**Pacific Sardine
Stock Assessment Review (STAR) Panel Meeting Report**

Southwest Fisheries Science Center (SWFSC),
National Oceanic and Atmospheric Administration (NOAA)
La Jolla, California
February 21-23, 2024

1: MexCal S1 weight-at-age by YEAR

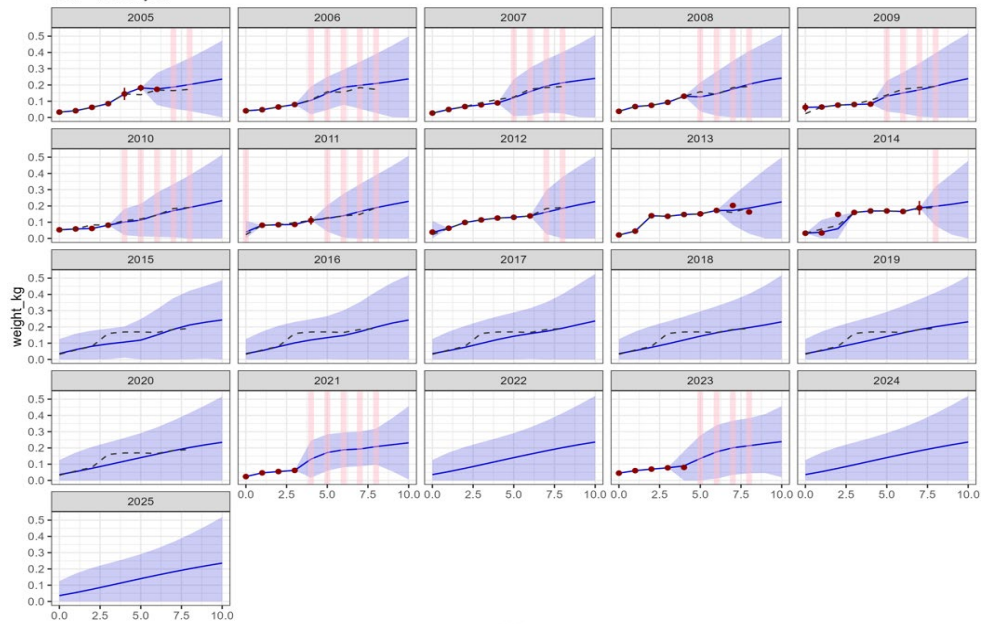
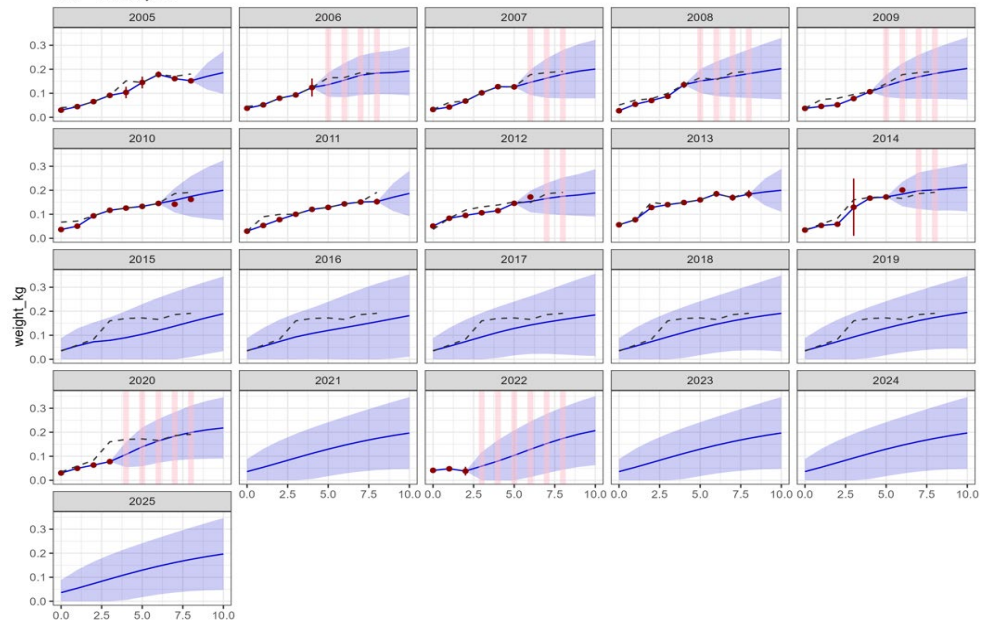
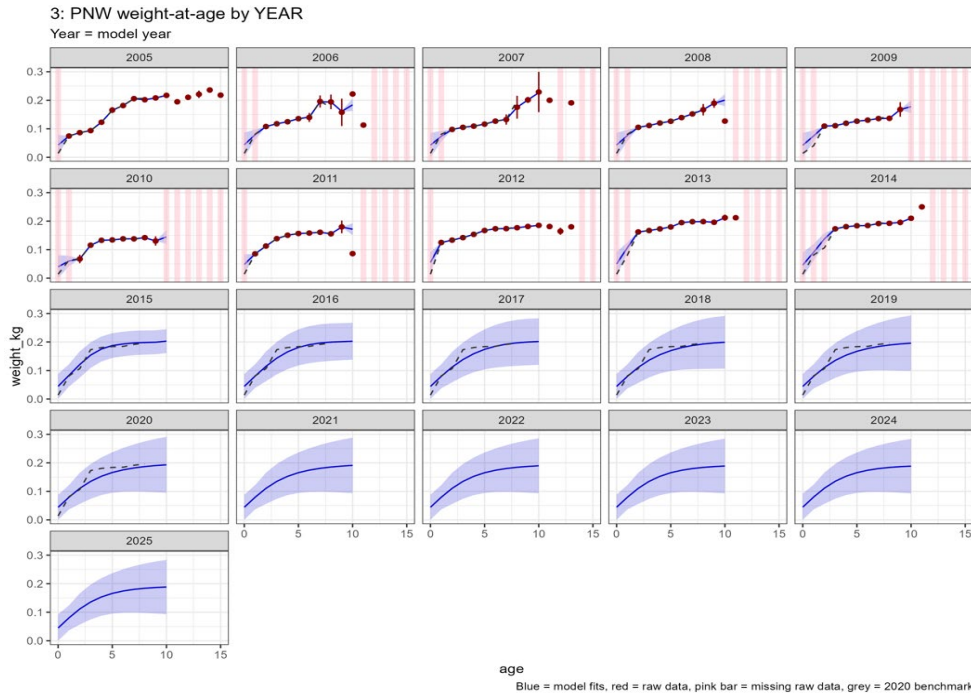
Request 14: More generally, the STAT should revisit the code used to plot fishery weight-at-age by season. If issues cannot be resolved, the STAT should present an alternative way forward (e.g., use similar methods to those used for the 2020 assessment).

Rationale: The 2024 model-based estimates appear to be poorly aligned with the data. There are also some highly unlikely estimates using the 2020 model (e.g., a decrease in mean weight at age-6 compared to age-5 in 2014).

STAT Response: Coding errors in generating plots were found and figures updated.
